Response to Comments (21st June)				
Transport Department (TD)Comments	Responses			
1. The proposed vehicular access leading to	Thanks for your comment.			
the site should be illustrated on the plans with	Please refer to attachment			
swept path analysis.	"LAYOUT PLAN" the access is illustrated.

LAYOUT PLAN

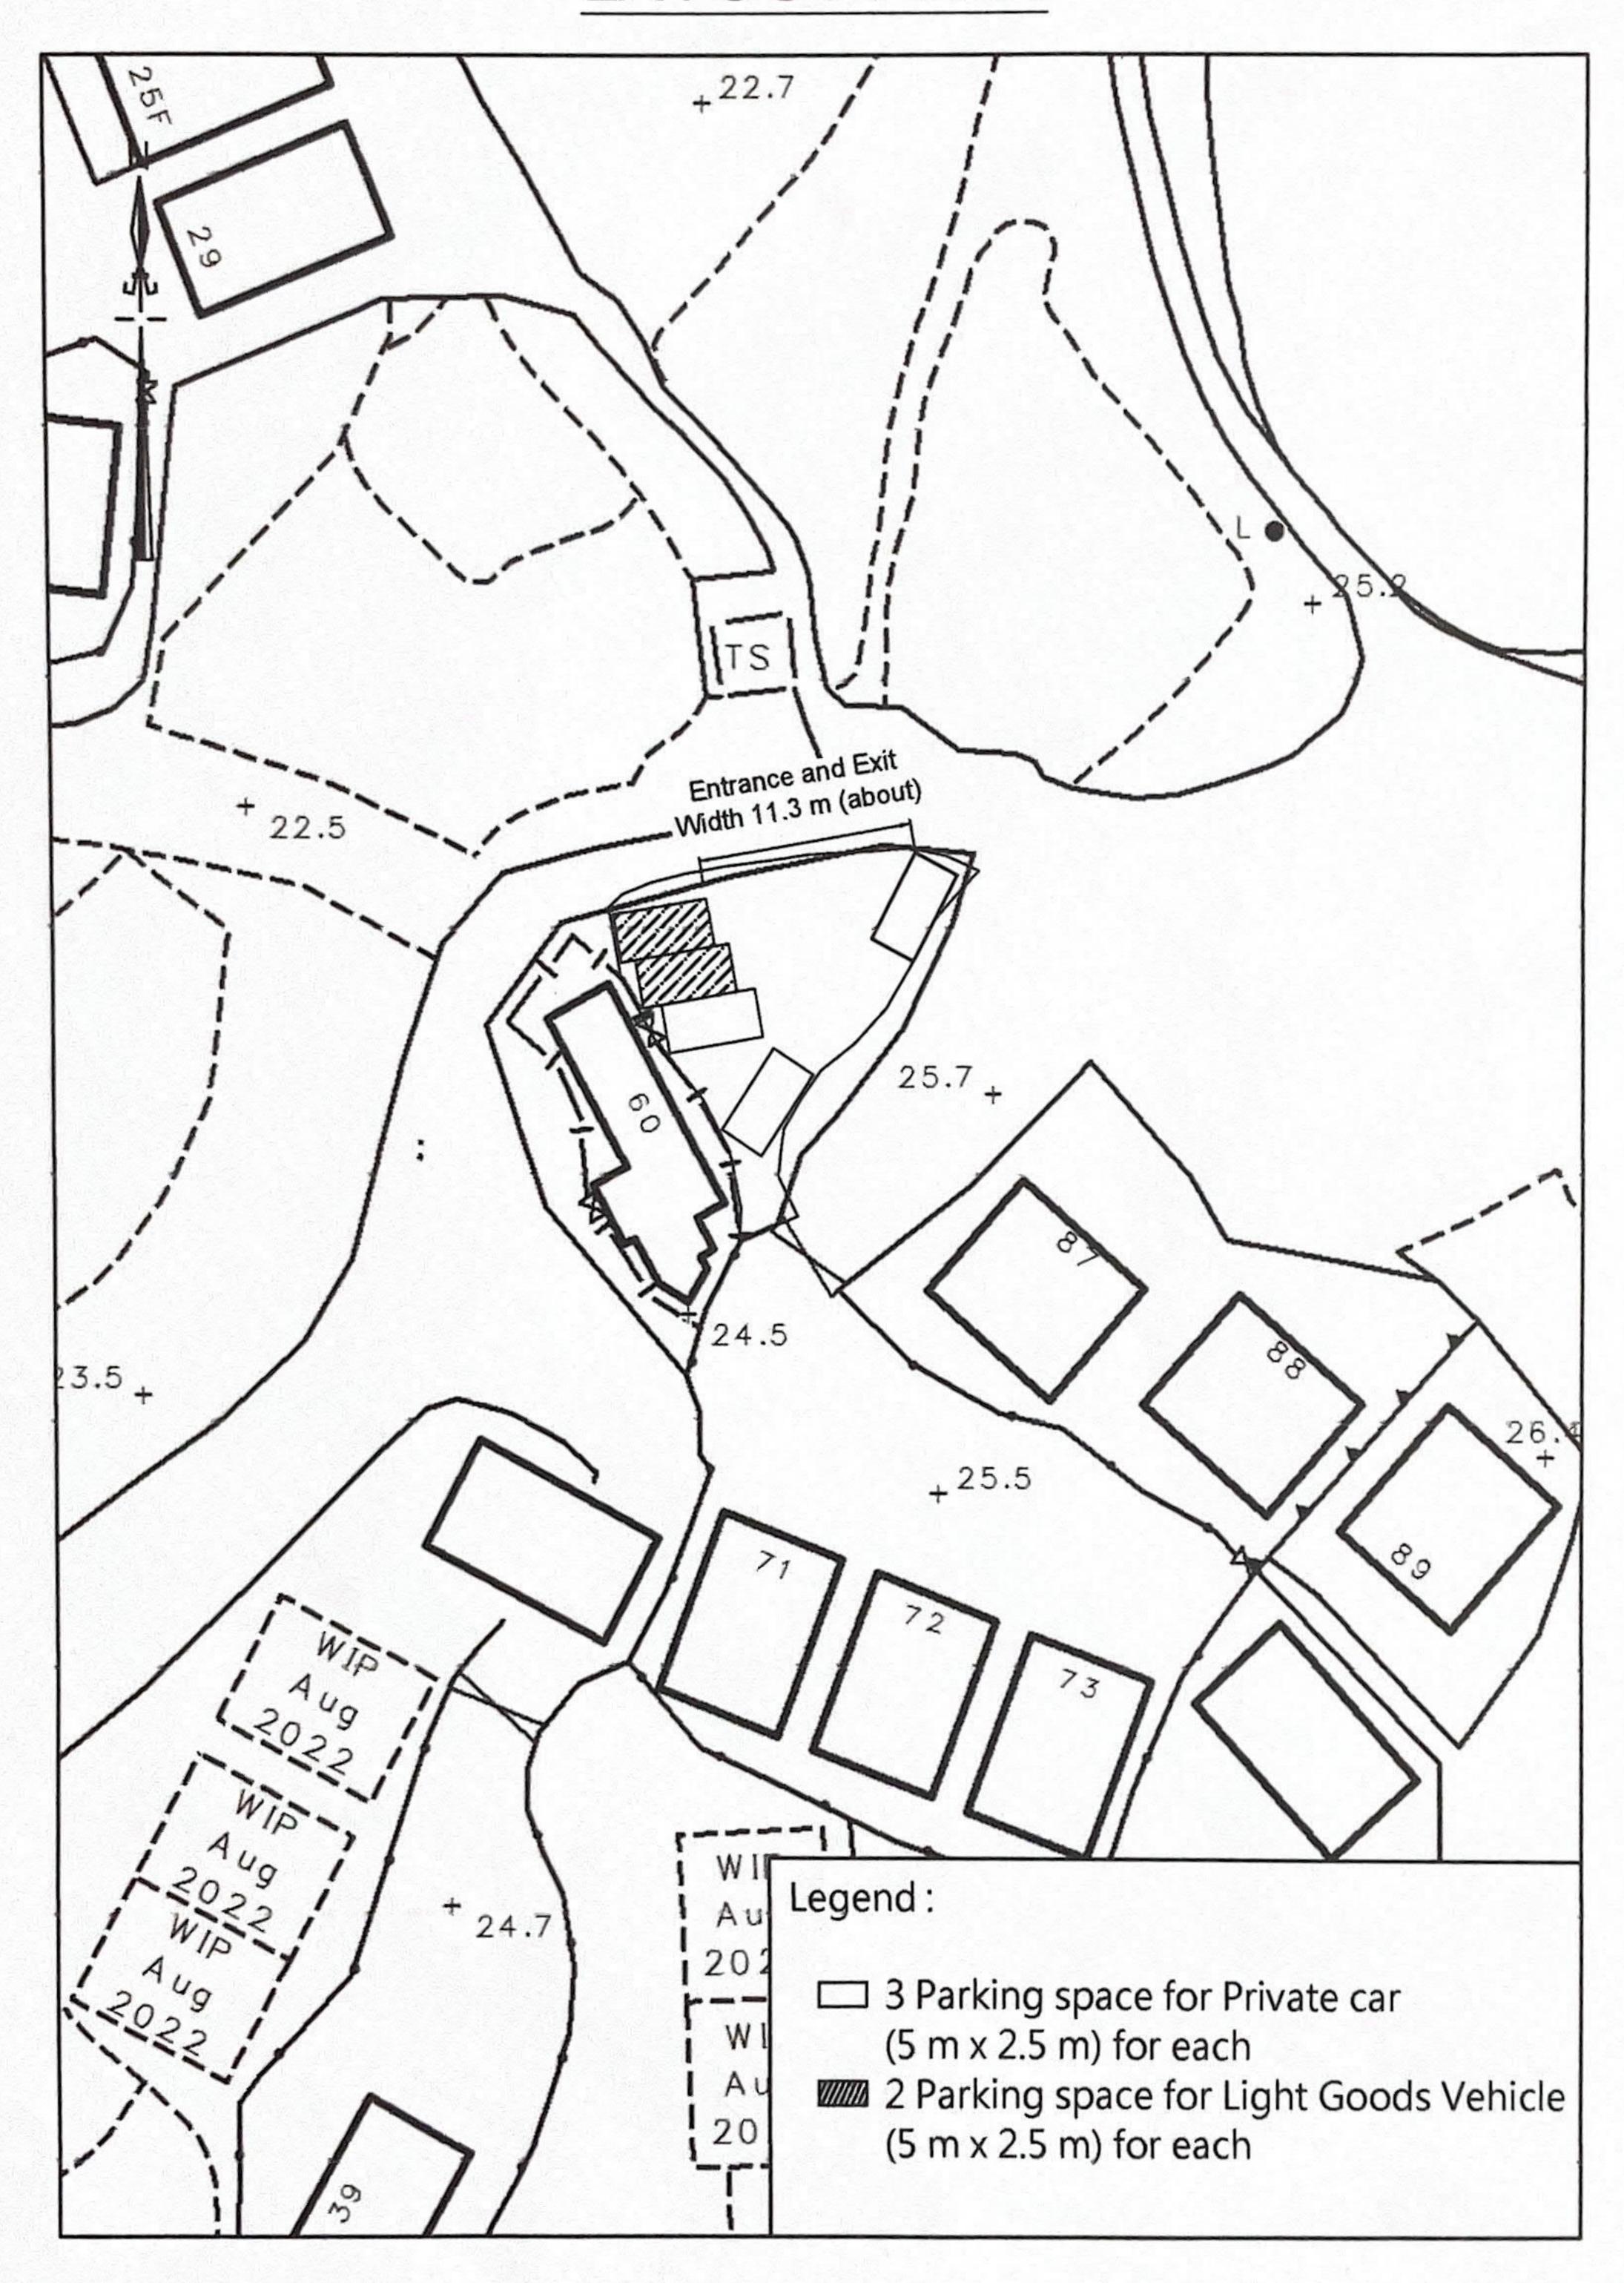
2. The proposed width of the vehicular access	Thanks for your comment.			
is 20m, which is considered very large. It poses	Considering the outline of			
potential hazard to other road users and	proposed site, the width of			
causes difficulty to pedestrians in crossing the	the vehicular access can be			
vehicular access. The width should be kept to	minimised to 11.3m about.			
the minimum compatible with satisfactory	Moreover ,2 road sign "			
operation of vehicles using the access. The	車場出入口,小心車輛" will			
applicant shall justify on the width of vehicular	be set at access to alert both			
access and its adequacy.	pedestrians and drivers.

3. Reverse movements to/from the applicant	Thanks for your comment.			
site should be avoid, which pose potential	Please refer to 5 revised			
hazard to other road users and cause difficulty	swept path analysis of each			
to pedestrians in crossing the run-in. Please	car parking. There are no			
revise the swept path analysis, if necessary	reverse movements occurred.			
revise the layout plan.
